# 2 Wire HD Video Intercom Solution Release Note (2024-05-15)

# 2 Wire HD Video Intercom Solution Release Note (2024-03-12)

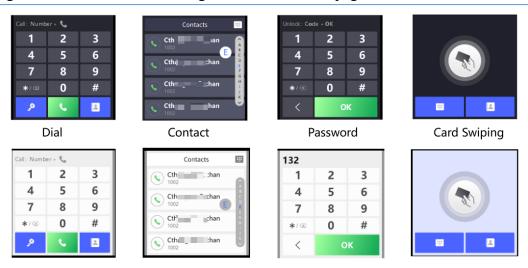
1. Compatible with new fingerprint & card module DS-KD-MFB (with acrylic front panel) and DS-KD-MFB/S (with stainless front panel), support M1 and Desfire card.

*Note*: Only support collecting and issuing fingerprints from the main module's web remote configuration, not support the use of iVMS-4200 to collect the fingerprints.

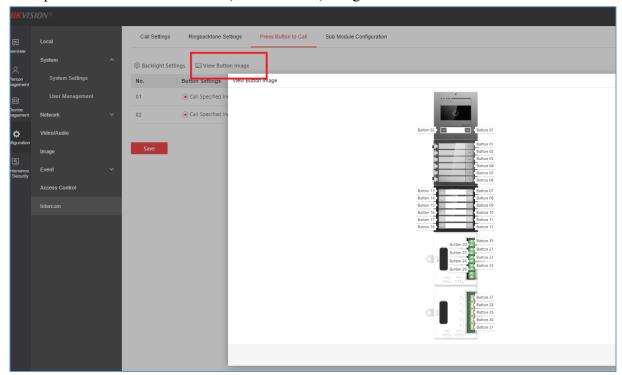
1. Compatible with new released 12 key nametag module DS-KD-K12 and DS-KD-K12/S

2. Update the default button No. (room number) image.
